**DESIGN MEMORANDUM 1
GENERAL DESIGN**

**MURRELLS INLET NAVIGATION PROJECT
GEORGETOWN COUNTY, SOUTH CAROLINA**

**REVISION OF
WEIR SYSTEM AND
JETTY & CHANNEL ALIGNMENTS**

SUBJECT: Murrells Inlet, South Carolina - Supplement No. 1 to the
General Design Memorandum - Revision of Weir System and
Jetty and Channel Alignments

U.S. ARMY ENGINEER DISTRICT CHARLESTON CORPS OF ENGINEERS CHARLESTON SOUTH CAROLINA		
NAVIGATION PROJECT		
JETTY & ENTRANCE CHANNEL PLAN		
MURRELLS INLET		
BERNETOWN COUNTY	SOUTH CAROLINA	
SCALE AS SHOWN	ORIGINAL DESIGN UNMODIFIED	PLATE 1
DATE 8/27/57	SUPPLEMENT # 1	FILE NO 10040

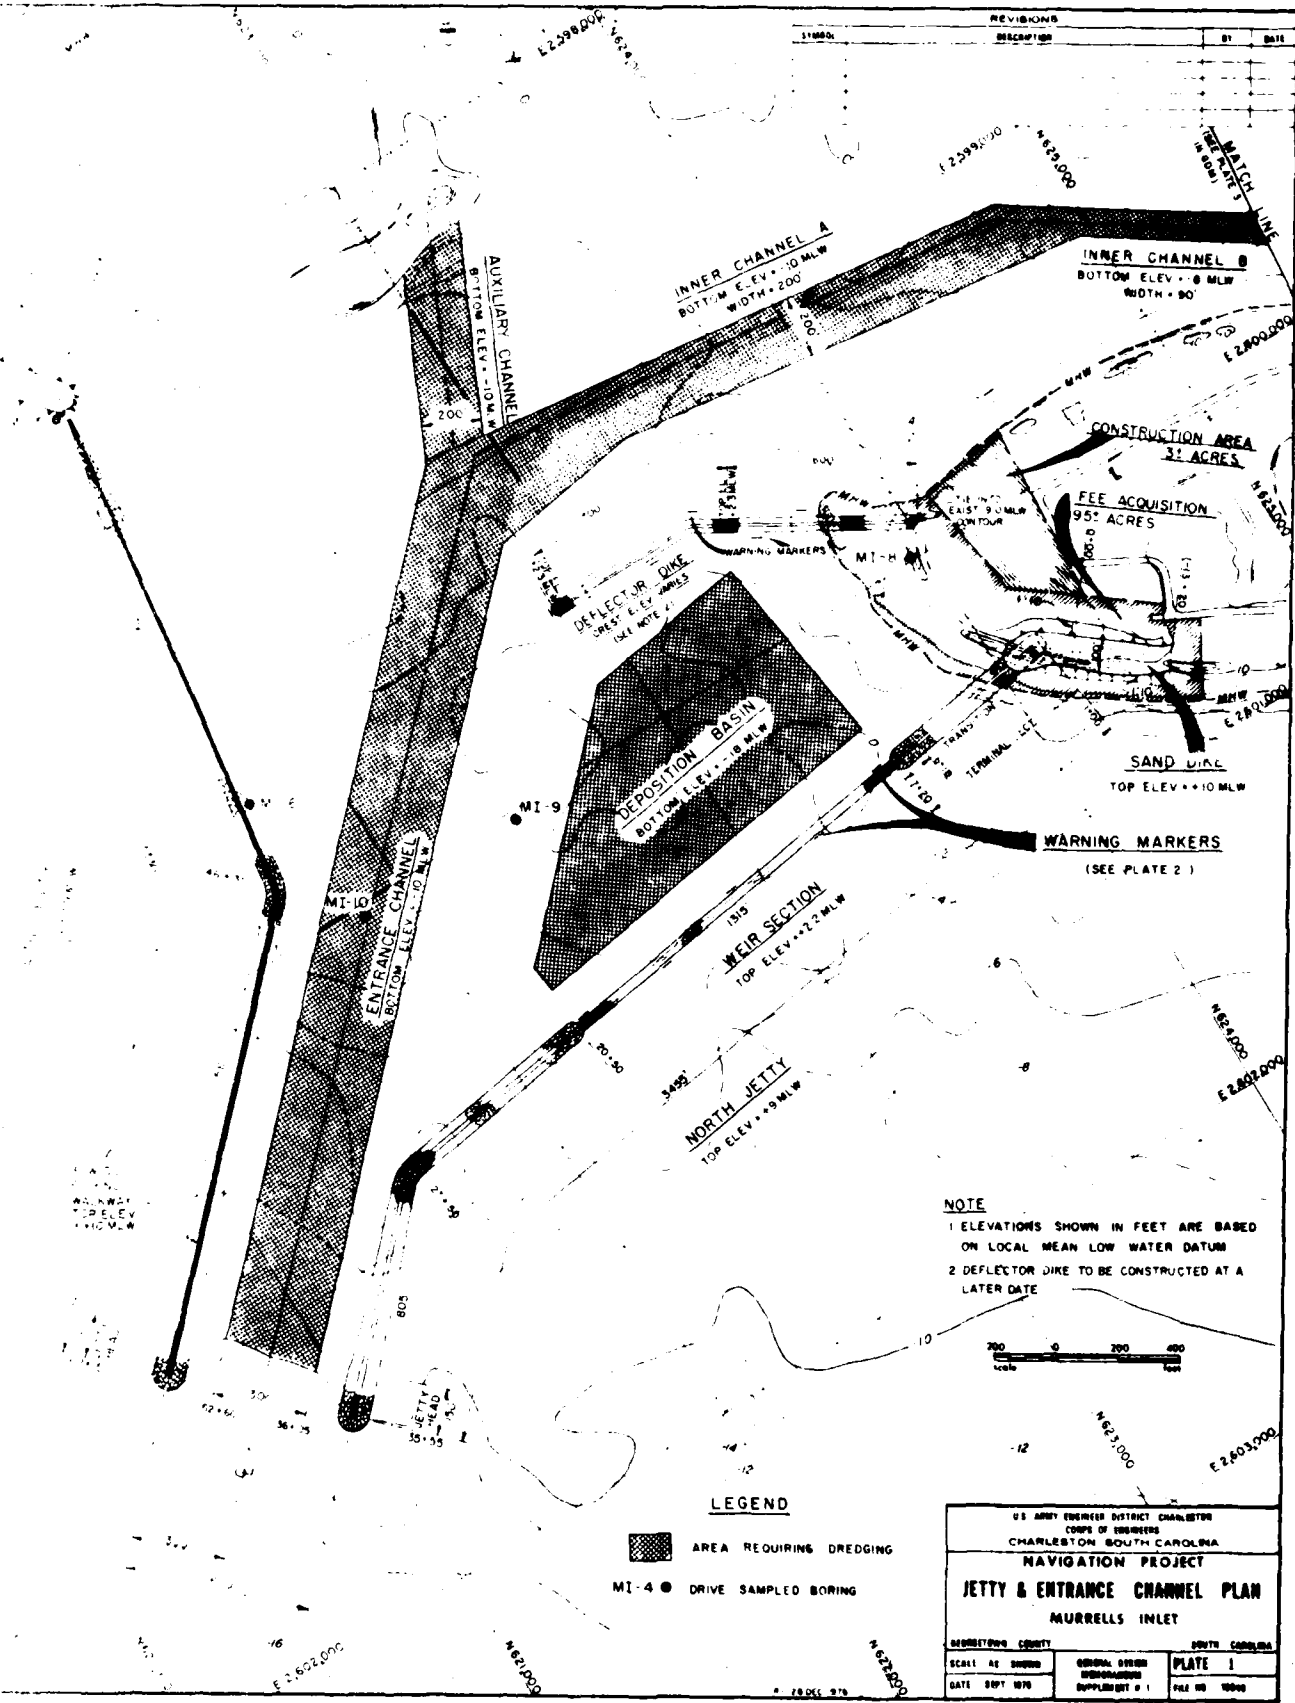
15. Channels. Channel widths and depths were changed as a result of model testing. See subparagraphs 10d (2), (3) and (4) above for details.

16. Jetties. Jetty spacing was reduced as a result of model testing. See subparagraph 10d (1), above for details. A jetty trunk section has been added to facilitate transitioning between the stone weir and the high land on the Garden City peninsula.

26. Entrance channel. The entrance channel would extend from the -10 feet ocean contour to a point within the jetties, a length of 3,000 feet. The entrance channel would be 300 feet wide and 10 feet deep. An allowable overdepth of 2 feet would be permitted to compensate for dredging inaccuracies. An additional overdepth of 2 feet to facilitate future maintenance in areas of hard bottom material would not be required. Since beach sands are known to compact very hard due to the vibratory action of the surf, it is believed that any shoal material (littoral drift) would compact just as hard. The compaction of the shoal material to the same degree as the in situ material would negate any possible benefits from advance maintenance overdepth. Side slopes of 1V on 4H would be expected initially after the box-cut dredging of the channel. Due to the wave action in the entrance channels, the ultimate side slope would probably be 1V on 10H. The distance between the edge of the channel and the jetty toe would be sufficient to allow an ultimate side slope of 1V on 10H, and at the same time provide a minimum distance of 25 feet to the toe of either jetty system.

27. Inner channel. The inner channel (consisting of Inner Channel A and Inner Channel B) would extend from the entrance channel through Main Creek to the old Army crash boat dock, a length of 15,440 feet, where it would terminate with a turning basin 300 feet long and 150 feet wide. Inner Channel A - starting at the entrance channel and extending 1,850

feet - would be 200 feet wide and have a bottom elevation of -10 feet mlw. Inner Channel B would be 13,590 feet long, 90 feet wide and would have a bottom elevation of -8 feet mlw. An allowable overdepth of 2 feet would be permitted to compensate for dredging inaccuracies. An additional overdepth of 2 feet to facilitate future maintenance in areas of hard bottom material would not be required. Side slopes of 1V on 4H would be expected after the box-cut dredging of the channel. Since there is little or no wave action in the inner channel, it is believed that this slope would remain stable once dredged.

U.S. ARMY ENGINEER DISTRICT CHARLESTON CORPS OF ENGINEERS CHARLESTON, SOUTH CAROLINA		
NAVIGATION PROJECT JETTY PROFILES MURRELLS INLET		
DESIGN TOWN COUNTY SOUTH CAROLINA	GENERAL DESIGN SUPERVISOR DATE SEPT 1950	SOUTH CAROLINA PLATE 2 FILE NO 10046

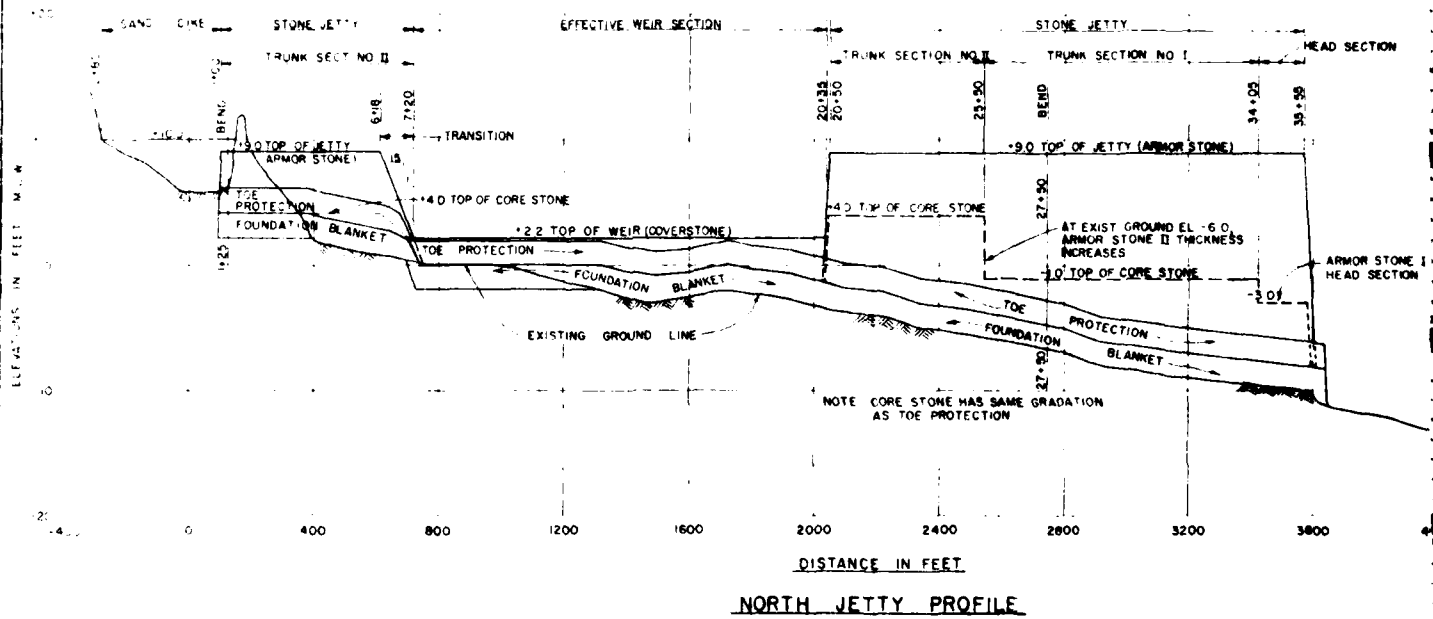
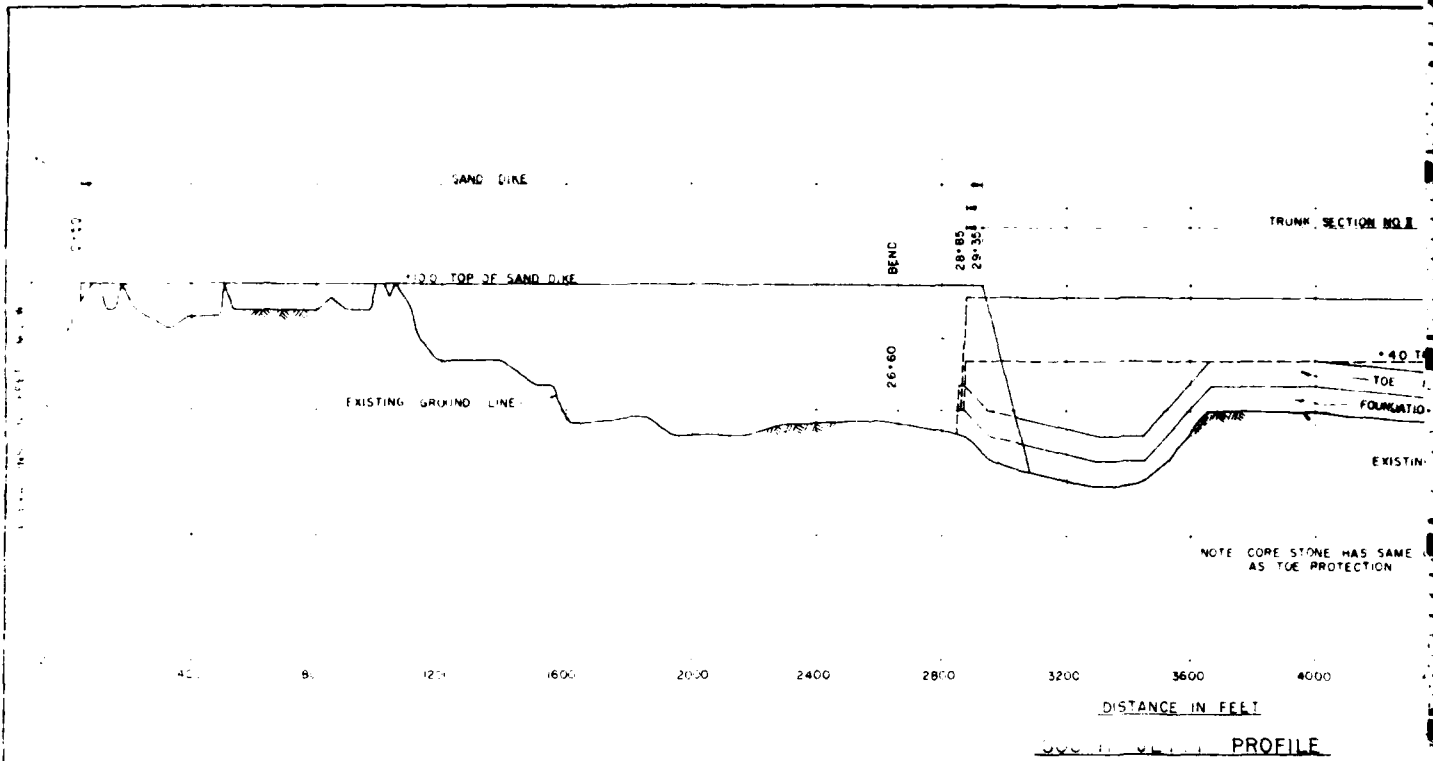
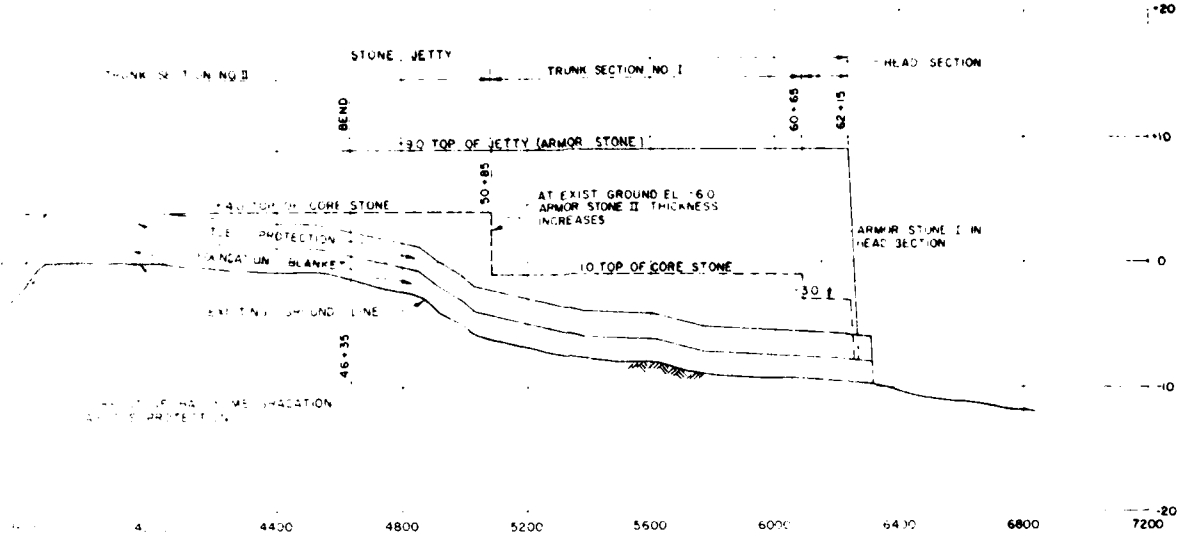
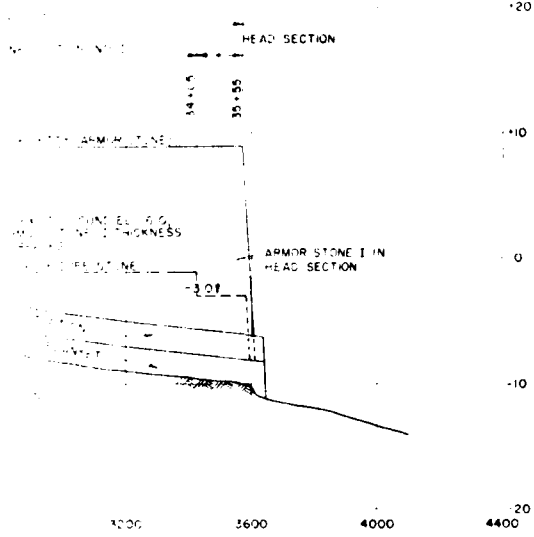
17. Weir. The weir section of the north jetty system has been changed from a concrete sheet pile type proposed in the GDM to a stone type. This change resulted from a conference at SAD on 20 August 1976 attended by representatives from CERC, OCE, SAD, and interested Districts of SAD. The stone weir system would be constructed to function in the same manner as the previously proposed concrete pile type. In effect, the weir crest would be established low enough to allow longshore drift to bypass into the deposition basin, but high enough to protect a dredge operating in the deposition basin under reasonably stable weather conditions.

Structurally, the stone weir system would have characteristics similar to the stone jetties. This system would be constructed of a foundation blanket, toe protection and armor stone (see Plates 2 and 3). The newly designed weir system is considered justified because of the following advantages over the concrete sheet pile weir.

20. North jetty. The proposed north jetty and weir system would be constructed entirely of quarystone from the shoreward end of an existing dune line to the -10 feet mlw ocean contour. The jetty would consist of a head section, a low weir section and two trunk sections as shown on Plate 2. The jetty section would start at a sand dune with a crest elevation of +9.0 feet mlw and continue for a distance of 518 feet; then transition from +9.0 feet mlw to +2.2 feet mlw (with a 1V on 15H slope) to the low weir section.

21. The low weir section would allow the passage of littoral drift traveling essentially between the shoreline and the -4 foot ocean contour. The effective weir section would be 1,315 feet long and have an average crest elevation of +2.2 feet mlw. The jetty trunk would then transition from +2.2 feet mlw to +9.0 feet mlw with a 1V on 2H slope. The jetty would remain at +9.0 feet mlw to its end (approximately 1505 feet). The total length of the north jetty is 3,455 feet. The head section consists of the outer 150 feet of jetty.

22. The head section would have two armor layers of 6-10 ton stones, a maximum crest width of 18 feet and side slopes of 1V on 2H. The jetty trunk - ocean side of weir - from the head to the -6 feet mlw ocean contour would have two armor layers of 4-7 ton stones, a maximum crest width of 15 feet and side slopes of 1V on 2H. The jetty trunk (from the -6 feet mlw contour to the weir) would have a single armor layer of 4-7 ton stones, a maximum crest width of 15 feet and side slopes of 1V on 2H. The weir section would have a single armor layer of variable size stones (ranging from 900 lbs. to 2.5 tons), a maximum crest width of 15 feet and side slopes of 1V on 2H. These stones would range from 2 feet to 3.5 feet in diameter and would provide a single cover layer along the weir. The landward jetty trunk would have a single armor layer of 4-7 ton stones, a maximum crest width of 15 feet and side slopes of 1V on 2H.

**NAVIGATION PROJECT
 JETTY & WEIR SECTIONS
 AND DEFLECTOR DIKE DETAILS**

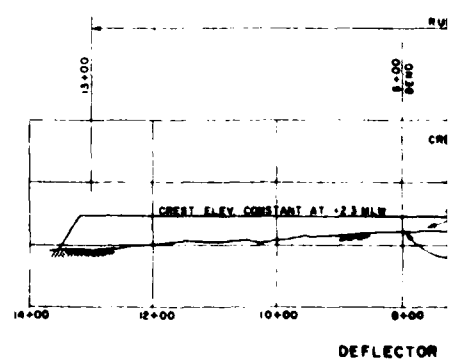
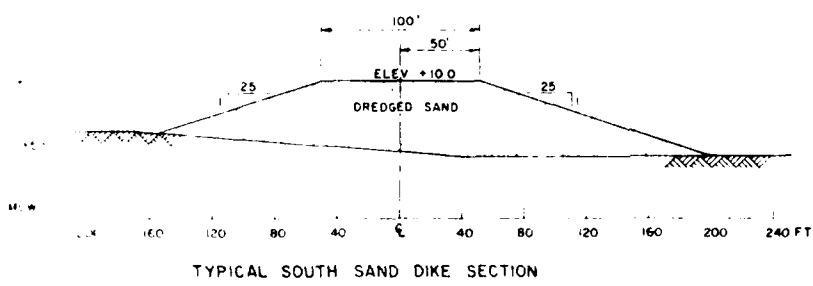
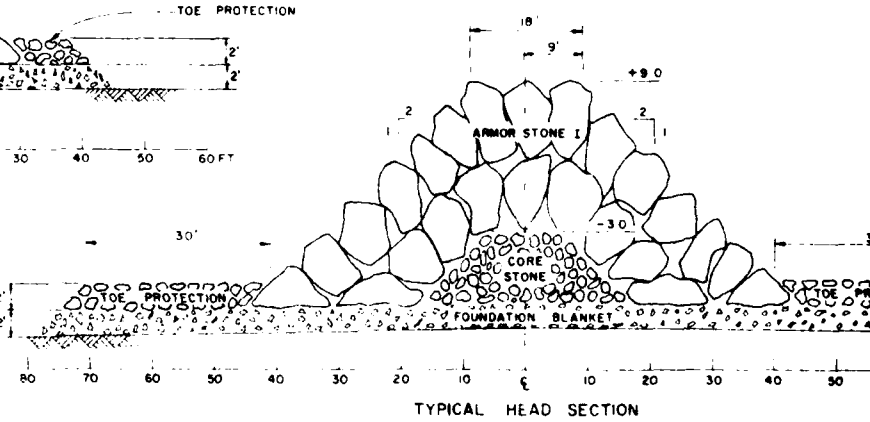
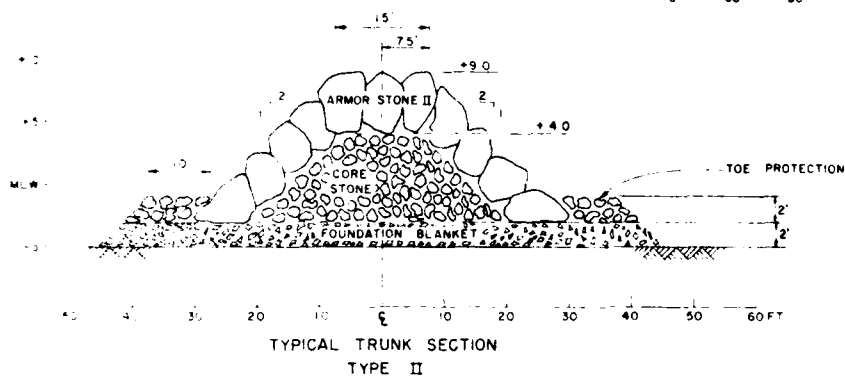
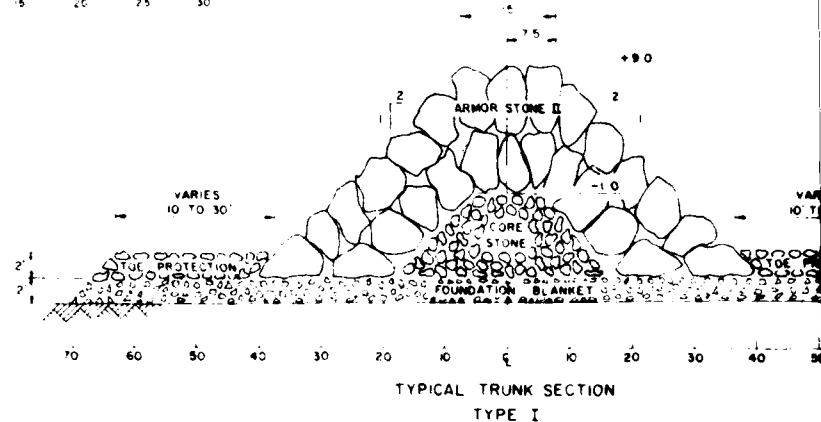
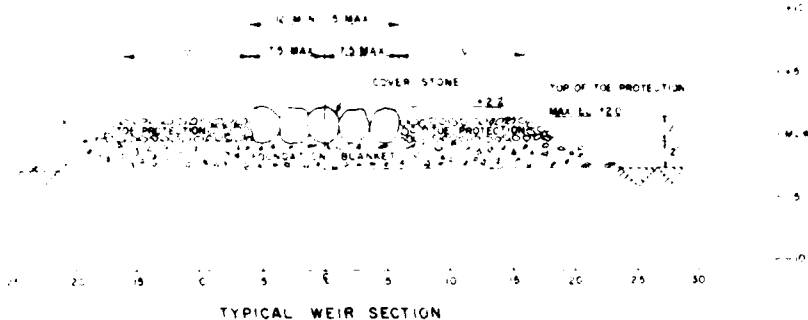
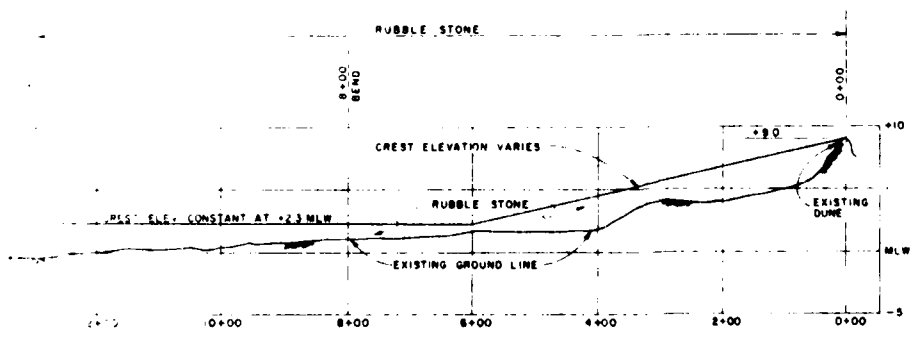
18. Deflector Dike. As a result of model testing it may be necessary to construct a deflector dike extending from the Garden City peninsula around the upper side of the deposition basin in order to prevent channel migration toward the deposition basin and north jetty. The deflector dike is shown on Plates 1, 1A and 3 and discussed in detail in paragraph 29. Model study information is presented in subparagraph 10i.

29. Deflector dike. The deflector dike would extend from an existing dune line (at elevation +9.0 feet mlw) on the Garden City side of the project into the inlet for a distance of 1,300 feet. The crest elevation would continually slope from +9.0 feet mlw to +2.3 feet mlw as shown on Plate 3; thence, remain constant at elevation +2.3 feet mlw to the end of the dike. It would be constructed of 100-900 pound stones and have no prepared foundation. The deflector dike would have a maximum crest width of 5 feet and side slopes of 1V on 2H. The purpose of the dike would be to deflect any ebb flow tending to migrate through the deposition basin. The deflector dike would not be planned for initial construction, but would be built at a later date should migration become evident.

FIGURE 13

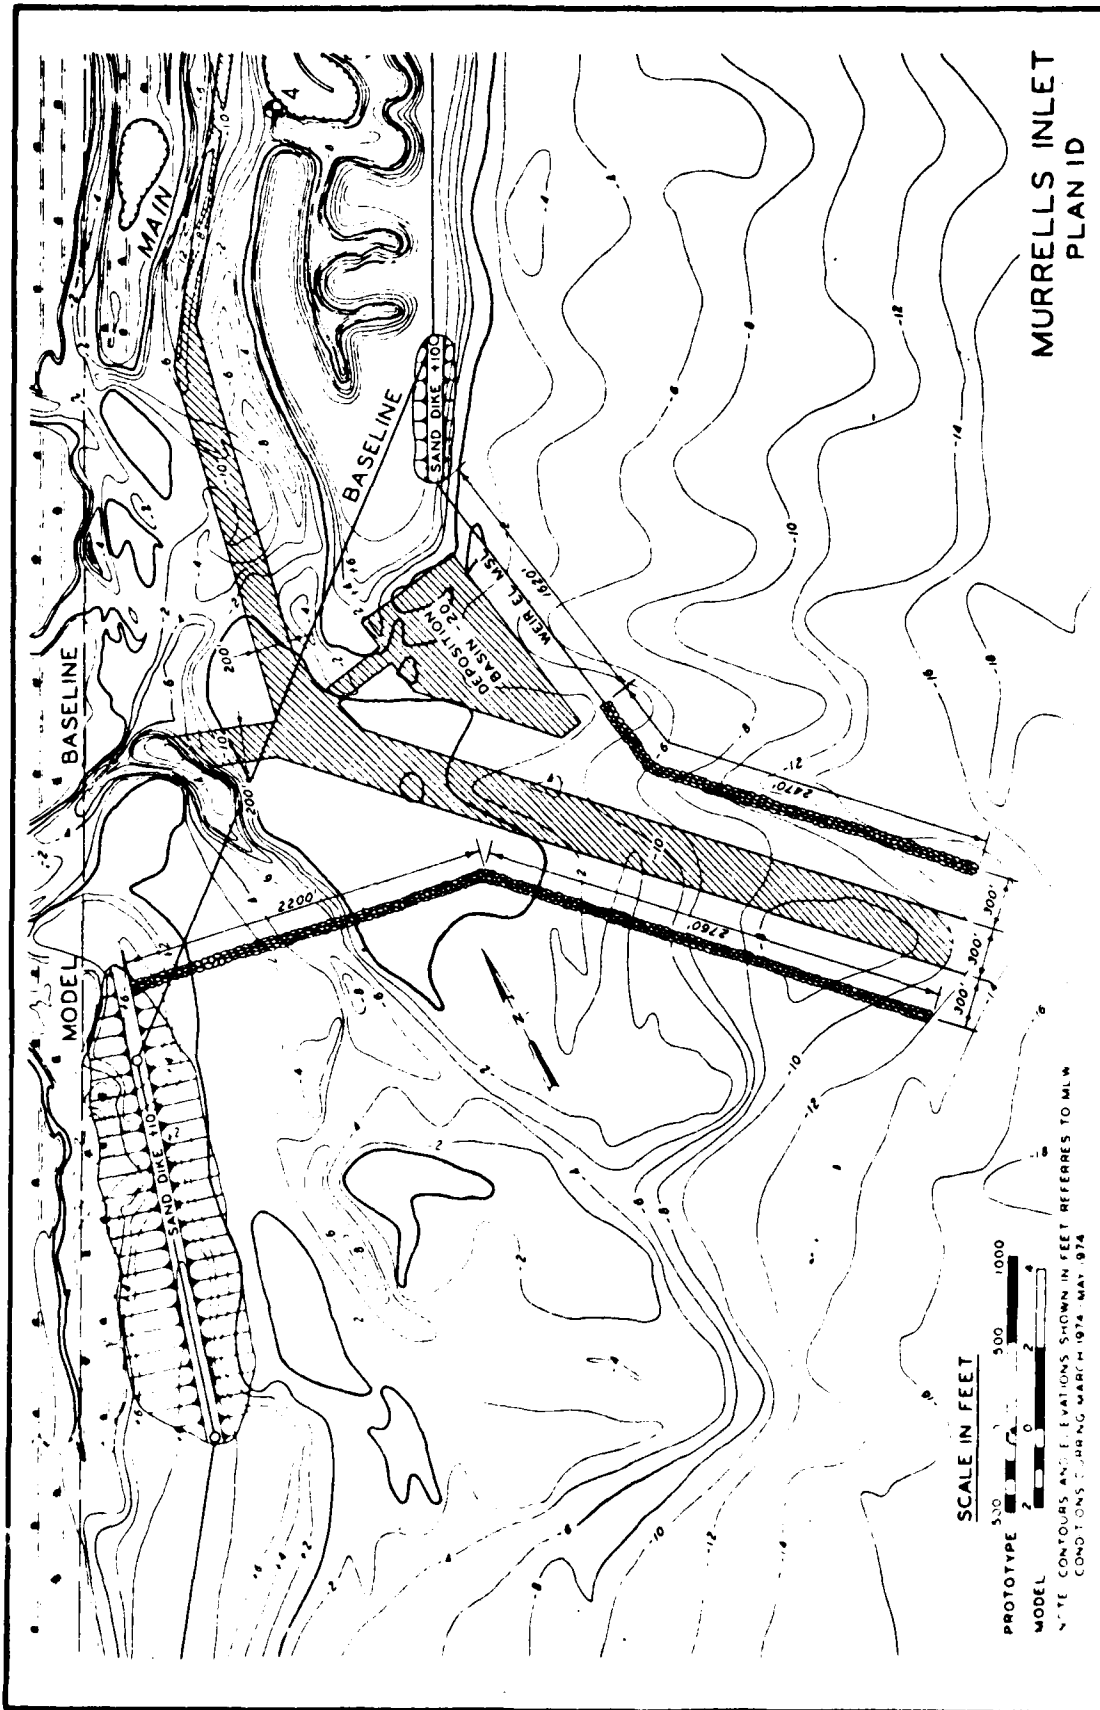
d. Plan 1D. As a result of testing and evaluation of Plan 1C and in recognition of the channel depth changes in the GDM plan, the following major revisions were made to develop Plan 1D (Figure 13):

(1) The jetty spacing was reduced from 900 feet to 600 feet wide to enhance the flushing action by increasing the velocity in the entrance channel.

(2) The proposed entrance channel was reduced in depth from -12 feet mlw to -10 feet mlw in order to increase the ebb velocities so that the probability of channel shoaling would be reduced.

(3) The depth of the proposed auxiliary channel leading to Oaks Creek was increased from -6 feet mlw to -10 feet mlw and the width was established at 200 feet to reduce the high velocities that could cause scouring and navigation hazards to smaller boats.

(4) The width of the initial section (Inner Channel A) of the proposed inner channel was increased from 90 to 200 feet; and, the depth was increased from -8 feet mlw to -10 feet mlw.

e. Surface current photography showed a pronounced tendency for ebb currents in this plan to migrate toward the north causing concern of a threat to the deposition basin and the north jetty.
